**Amendment-IX dated 18.04.2024 on the RFP Documents for Selection of Bidder as Transmission Service Provider to establish Inter-State Transmission System for “Transmission System for Evacuation of power from potential renewable energy zone in Khavda area of Gujarat under Phase-IV (7GW): Part A” through tariff based competitive bidding process.**

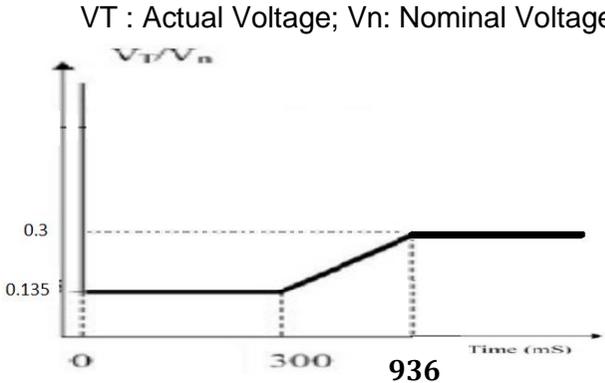
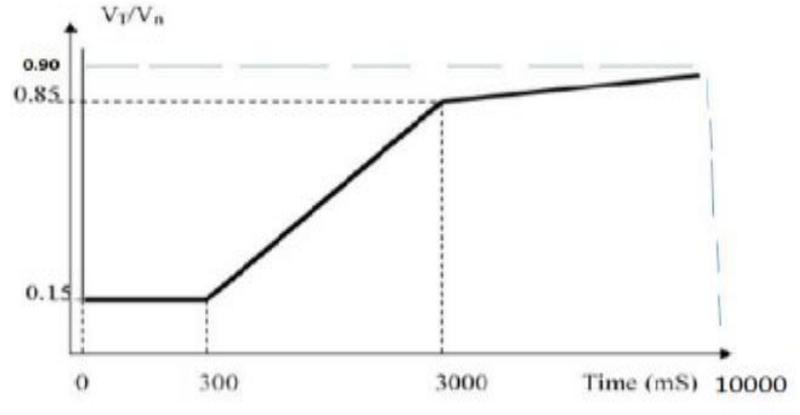
Sl. No.	Clause No.	Existing Clause	New/Revised Clause
			respective RLDC, however all the necessary support in this regard shall be ensured by TSP. The maintenance of all the PMUs and associated equipment shall be the responsibility of TSP.
7	<b>Power System Characteristic of STATCOM</b>	<p>The STATCOMs shall remain connected to the grid and shall be able to operate at rated reactive power capability when voltage at the interconnection point, on any or all phases dips up to the level depicted by the thick lines in the following curve (for specified time):</p> <p>VT : Actual Voltage; Vn: Nominal Voltage</p> 	<p><b><u>For STATCOMs near RE complex:</u></b></p> <p>The STATCOMs shall remain connected to the grid and shall be able to operate at rated reactive power capability when voltage at the interconnection point, on any or all phases dips up to the level depicted by the thick lines in the following curve (for specified time):</p> <p>VT : Actual Voltage; Vn: Nominal Voltage</p>

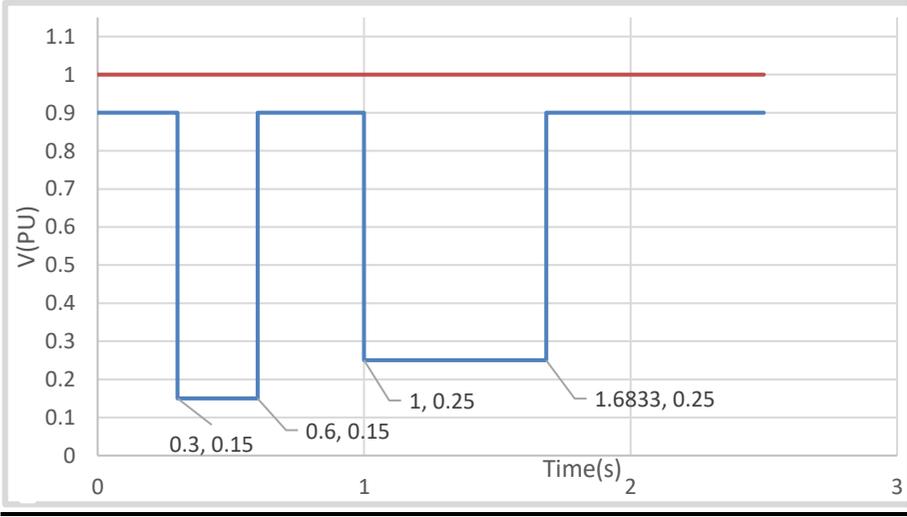
9	C.6.1  STATCOM Station Ratings	<p>.....</p> <p>.....</p> <p>e) The STATCOM <b><u>should</u></b> continue to absorb reactive power during <b><u>temporary over voltages</u></b> in a controlled manner as per the following.</p> <table border="1" data-bbox="448 1252 1048 1420"> <thead> <tr> <th><u>Temporary Overvoltage</u></th> <th><u>Duration</u></th> </tr> </thead> <tbody> <tr> <td><u>up to 600 kV (1.5 pu)</u></td> <td><u>10 seconds</u></td> </tr> <tr> <td><u>up to 704 kV (1.76 pu)</u></td> <td><u>100 milli sec</u></td> </tr> <tr> <td><u>up to 800 kV (2.0 pu)</u></td> <td><u>50 milli sec</u></td> </tr> </tbody> </table>	<u>Temporary Overvoltage</u>	<u>Duration</u>	<u>up to 600 kV (1.5 pu)</u>	<u>10 seconds</u>	<u>up to 704 kV (1.76 pu)</u>	<u>100 milli sec</u>	<u>up to 800 kV (2.0 pu)</u>	<u>50 milli sec</u>	<p>.....</p> <p>.....</p> <p>e) The STATCOM <b><u>shall</u></b> continue to absorb reactive power during <b><u>HVRT Conditions</u></b> in a controlled manner as per the following.</p> <table border="1" data-bbox="1326 1212 2116 1420"> <thead> <tr> <th><u>Nominal Voltage (pu)</u></th> <th><u>Minimum time for remaining connected to the Grid</u></th> </tr> </thead> <tbody> <tr> <td><u>V &gt; 1.50</u></td> <td><u>Instantaneous trip</u></td> </tr> <tr> <td><u>1.50 ≥ V &gt; 1.30</u></td> <td><u>100 milli seconds</u></td> </tr> <tr> <td><u>1.30 ≥ V &gt; 1.10</u></td> <td><u>10 seconds</u></td> </tr> </tbody> </table>	<u>Nominal Voltage (pu)</u>	<u>Minimum time for remaining connected to the Grid</u>	<u>V &gt; 1.50</u>	<u>Instantaneous trip</u>	<u>1.50 ≥ V &gt; 1.30</u>	<u>100 milli seconds</u>	<u>1.30 ≥ V &gt; 1.10</u>	<u>10 seconds</u>

<u>Temporary Overvoltage</u>	<u>Duration</u>																		
<u>up to 600 kV (1.5 pu)</u>	<u>10 seconds</u>																		
<u>up to 704 kV (1.76 pu)</u>	<u>100 milli sec</u>																		
<u>up to 800 kV (2.0 pu)</u>	<u>50 milli sec</u>																		
<u>Nominal Voltage (pu)</u>	<u>Minimum time for remaining connected to the Grid</u>																		
<u>V &gt; 1.50</u>	<u>Instantaneous trip</u>																		
<u>1.50 ≥ V &gt; 1.30</u>	<u>100 milli seconds</u>																		
<u>1.30 ≥ V &gt; 1.10</u>	<u>10 seconds</u>
